Project	<b>IEEE 802.16 Broadband Wireless Access Working Group</b> < <a href="http://ieee802.org/16">http://ieee802.org/16</a> >	
Title	<b>Enhancement to the BS-initiated Handover</b>	
Date Submitted	<b>2004-05-07</b>	
Source(s)	HyoungKyu Lim Sungjin Lee Jungje Son Changhoi Koo Samsung Electronics, Suwon P.O.Box 105, 416, Maetan-3dong, Paldal-gu, Suwon-si, Gyeonggi-do, Korea 442-742	Voice : +82-31-279-5091 Fax : +82-31-279-5130  <a href="mailto:hk03.lim@samsung.com">hk03.lim@samsung.com</a> <a href="mailto:steve.lee@samsung.com">steve.lee@samsung.com</a> <a href="mailto:jungje.son@samsung.com">jungje.son@samsung.com</a> <a href="mailto:chkoo@samsung.com">chkoo@samsung.com</a>
Re:	This contribution is response to call for contribution about IEEE802.16e-D2	
Abstract	This contribution is to propose a network-assisted BS-initiated HO in order to make it short the HO execution time.	
Purpose	Discuss and Adopt the advanced feature for BS-initiated HO in the IEEE802.16e group.

# Enhancement of BS initiated Handover

**Figure E.11 Example Network-assisted HO process by BS request and MSS decision of Target BS**

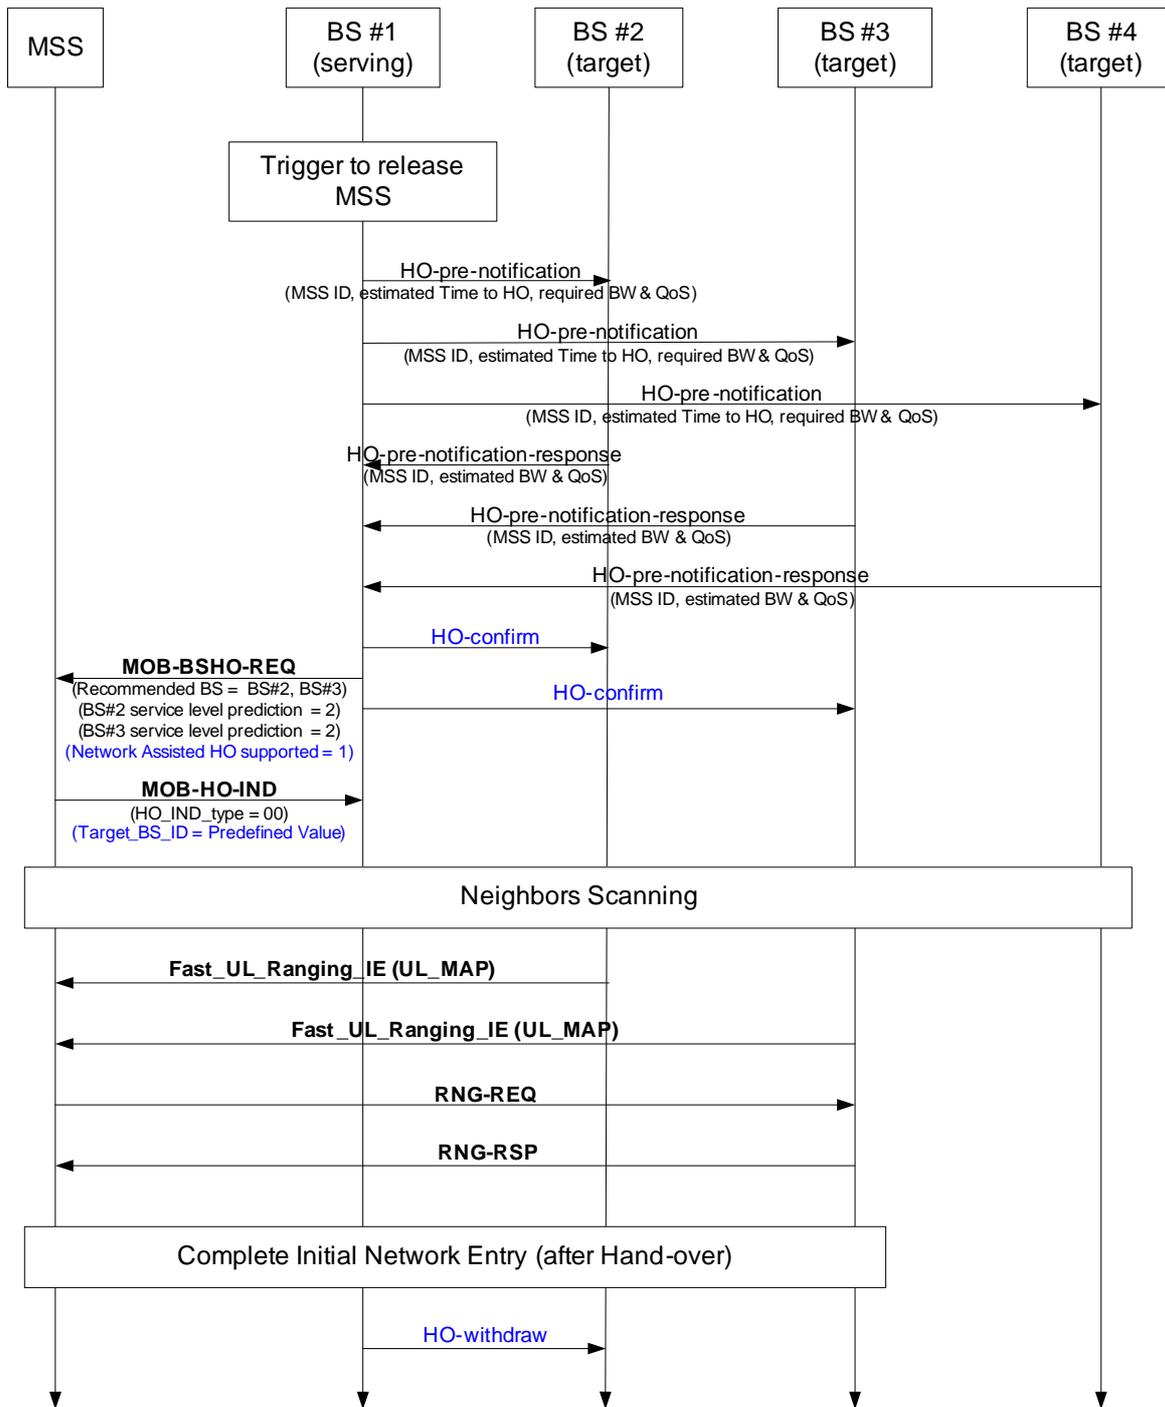
[Add the following figure to the end of E.1 in Page 116, Line 51:]
